Access Compliance Report

Public Rights-of-Way

Intersection ID: 29713	Main Street: COLE_MILL_RD	Cross Street: ROBESON_CREEK_DR	Location: S
ADA ID: 979F764EA5EC	Ramp Type: BlendTrans1	Initial Pass/Fail: Fail	Overall Compliance: No
Severity Score: 8.75			
Codes/Mitigation Info/Possible Solution		Field Measurements/Component Compliance

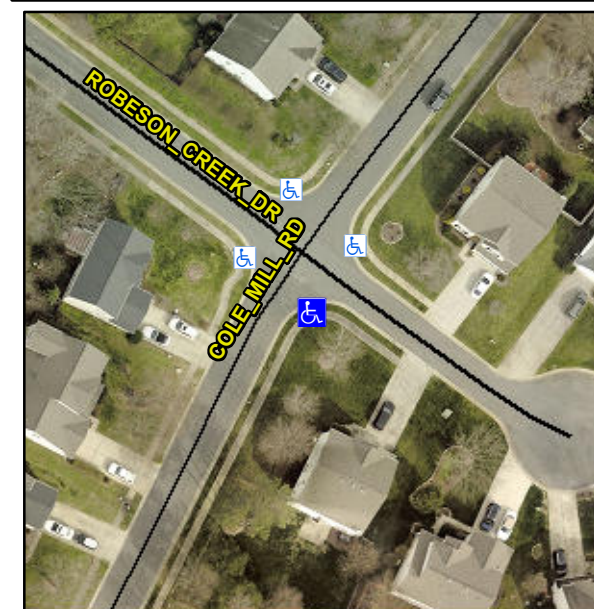
R304.5.1

Compliance	Description	Data	Compliance	Description	Data
N/A	Ramp Length (in)	45.0	Yes	BlendTrans Slope (%)	1.2
No	Ramp Width (in)	47.0	Yes	BlendTrans XSlope (%)	1.8
N/A	Flare Type LT	N/A	N/A	Flare Type RT	N/A
N/A	Flare Slope LT (%)	N/A	N/A	Flare Slope RT (%)	N/A
N/A	Flare Traversable LT?	N/A	N/A	Flare Traversable RT?	N/A
N/A	Landing Length (in)	N/A	N/A	DWS Provided?	N/A
N/A	Landing Width (in)	N/A	N/A	DWS Contrast?	N/A
N/A	Landing Slope (%)	N/A	N/A	DWS Length (in)	N/A
N/A	Landing X Slope (%)	N/A	N/A	DWS Full Width?	N/A
N/A	Landing Curb? (Y/N)	N/A	N/A	DWS Offset (in)	N/A
N/A	Shared Landing?	N/A			
N/A	Gutter Ponding?	N/A	N/A	Gutter Slope (%)	N/A
N/A	Gutter Lip Ht (in)	N/A	N/A	Gutter X Slope (%)	N/A
N/A	Painted X Walk1?	No	N/A	Painted X Walk2?	No
	X Walk 1 Direction	To NE		X Walk 2 Direction	To NW
	X Walk 1 Width (in)	N/A		X Walk 2 Width (in)	N/A
	X Walk 1 Slope (%)	6.5		X Walk 2 Slope (%)	2.5
	X Walk 1 X Slope (%)	0.5		X Walk 2 X Slope (%)	4.8

Remove & Replace Curb Ramp With Two New Directional Ramps or Equivalent.
